**RE: Presbyterian Hospital "Make-Ready" Site Improvements
100 Central SE
Grading and Drainage Plan
Engineer's Stamp Date: 9/18/19
Hydrology File: K15D005**

Re: Presbyterian Healthcare Services Site Improvements – Hydrology Resubmittal: Hydrology File:
K15D005

PRESBYTERIAN HOSPITAL
SITE IMPROVEMENTS
1100 Central Avenue SE
Albuquerque, NM 87106

EXISTING
DRAINAGE
MANAGEMENT
PLAN

A1 EXISTING DRAINAGE MANAGEMENT PLAN - SOUTHWEST LOT
1" = 20'-0"

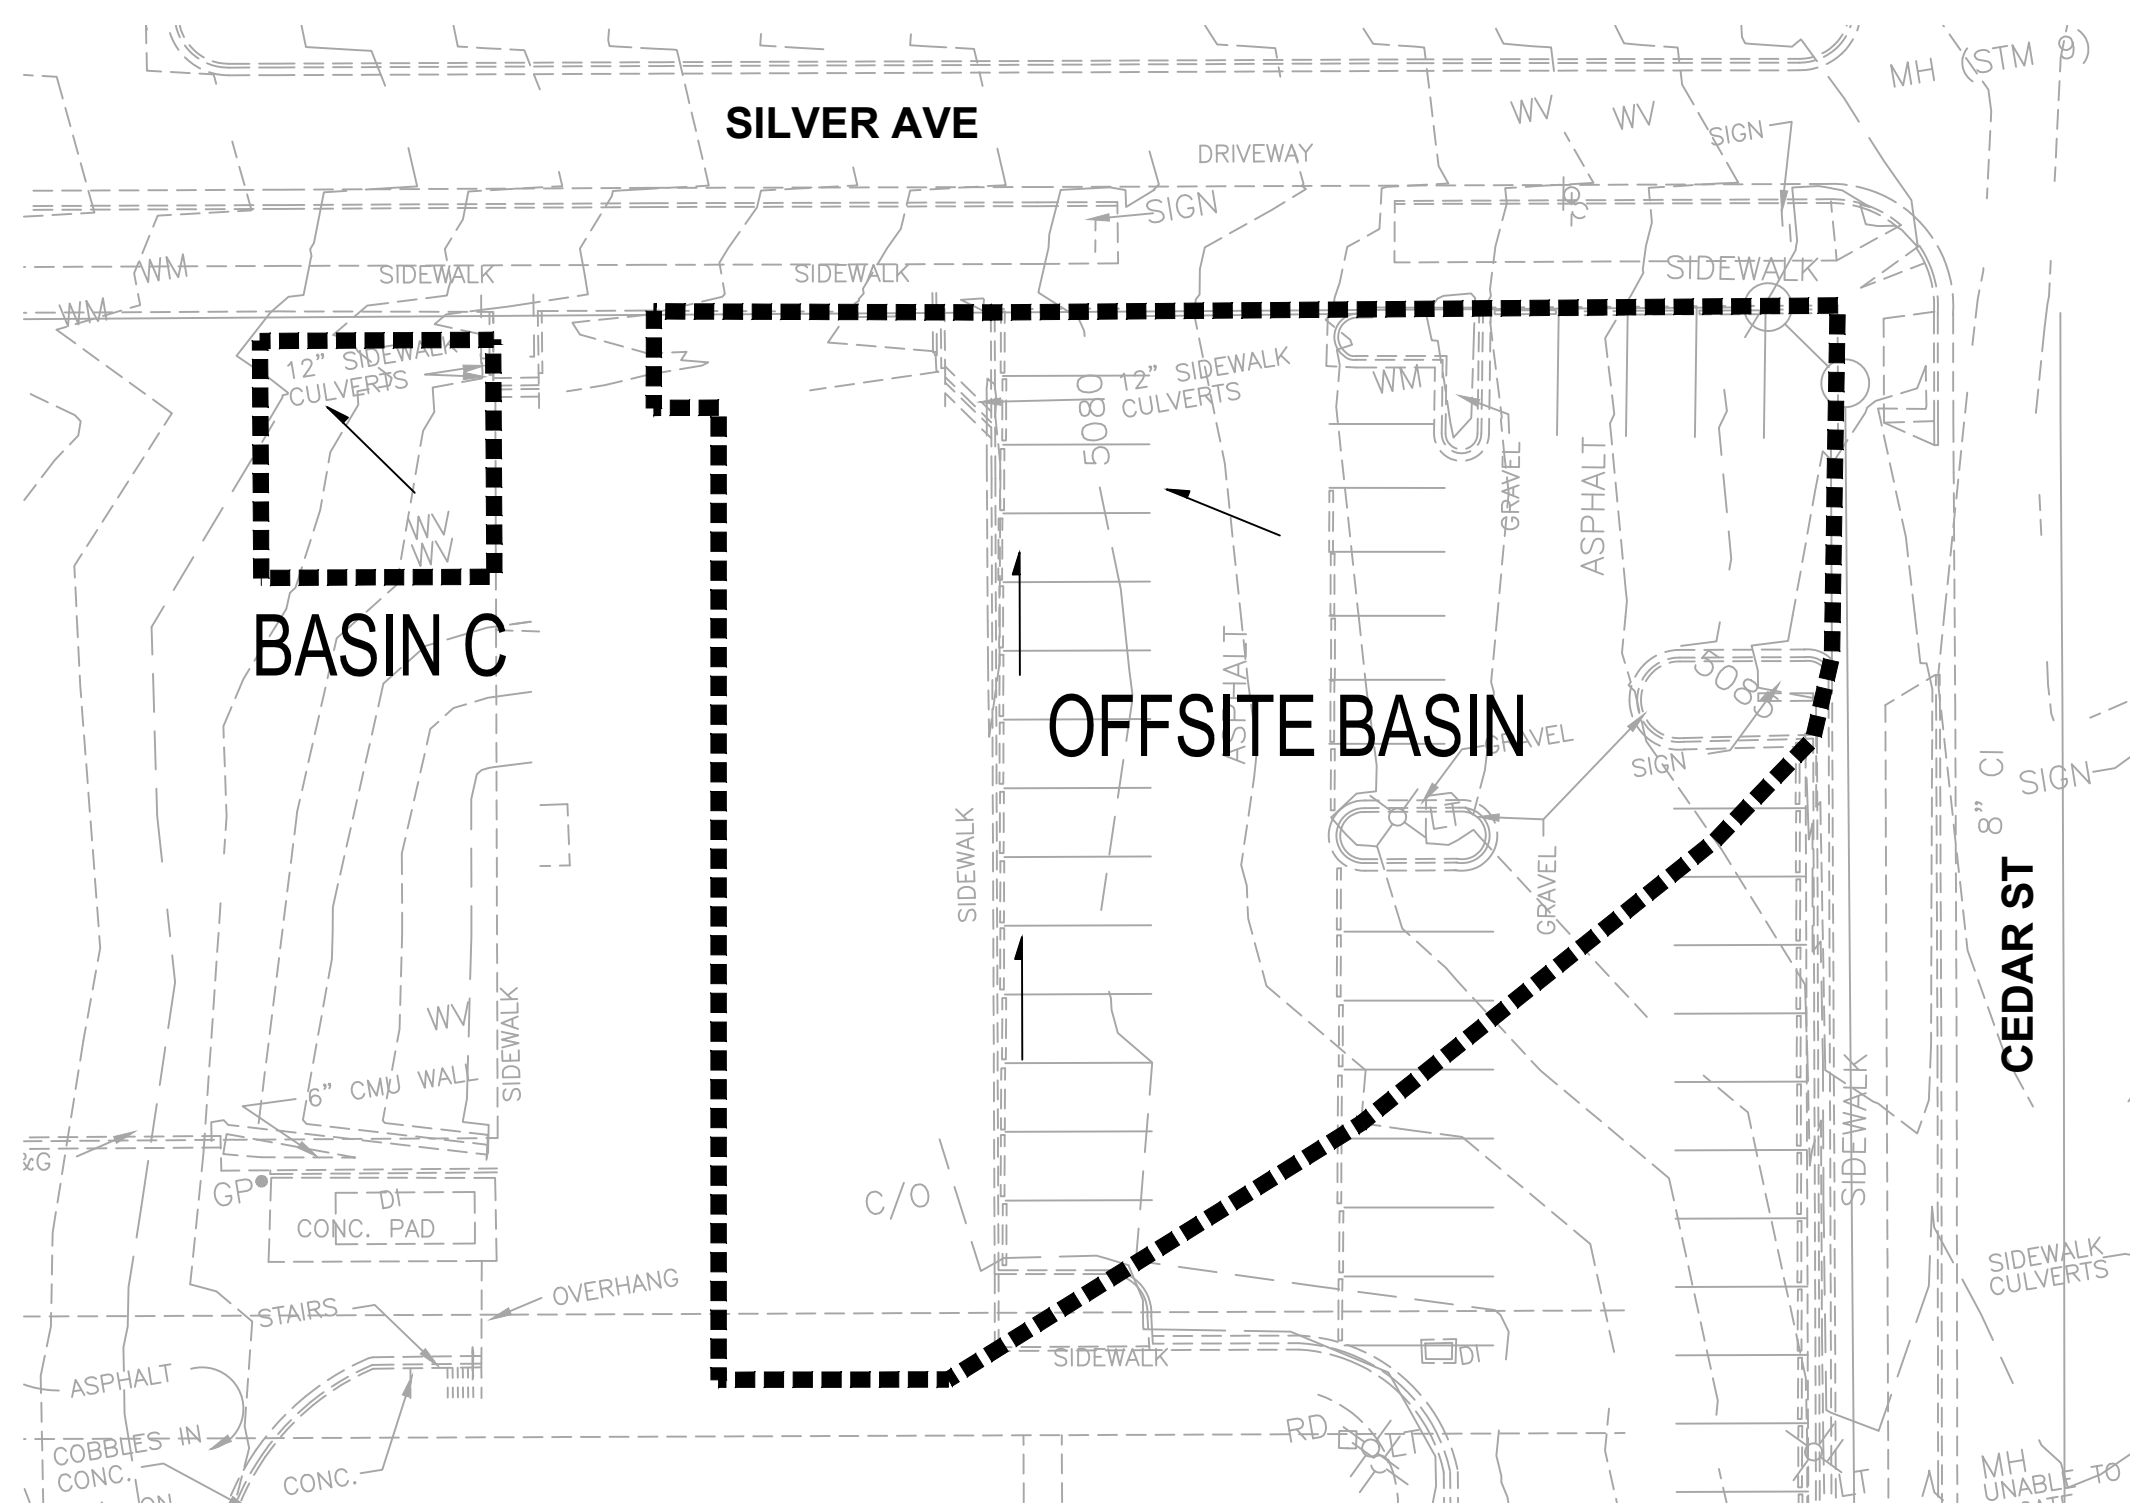
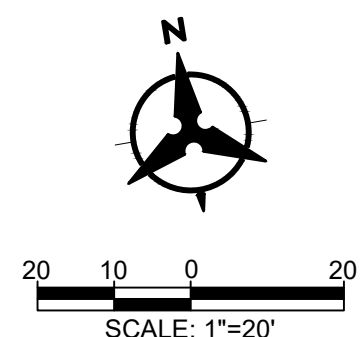
3. Each portion of the project (viewport) needs to include the street names.

4. Screenback or turn-off the extraneous survey layers.

6. Provide management onsite for for the Stormwater Quality Volume (SWQV) in accordance with the new drainage ordinance, § 14-5-2-6 (H) enacted 10/2/18 (Council Bill C/S O-18-2). You may elect to make Payment-in-Lieu for the onsite management for the volume not captured. In order to pursue this, the plan must state that: you could provide onsite management, you do not want to (due to cost or convenience), and you are electing to make the Payment-in-Lieu of onsite management.

7. This site qualifies as redevelopment and is only required to retain runoff from the 80th percentile storm (Vol.=0.26*Imp. Area).

10. Hydraulic calculations per the DPM Ch.22.3 are required for all sidewalk culverts, swales, storm drain, etc..

Response: This information has been added.

Response: The background information has been cleaned up to make the drawing more legible.

Response: Due to site constraints onsite management will not be provided and the owner has

elected to make Payment-in-Lieu of onsite management. This has been noted on the drainage management plan.

Response: Noted. The onsite drainage management volumes have been calculated based on the method noted in your comment.

Response: Calculations have been added to the Proposed DMP.
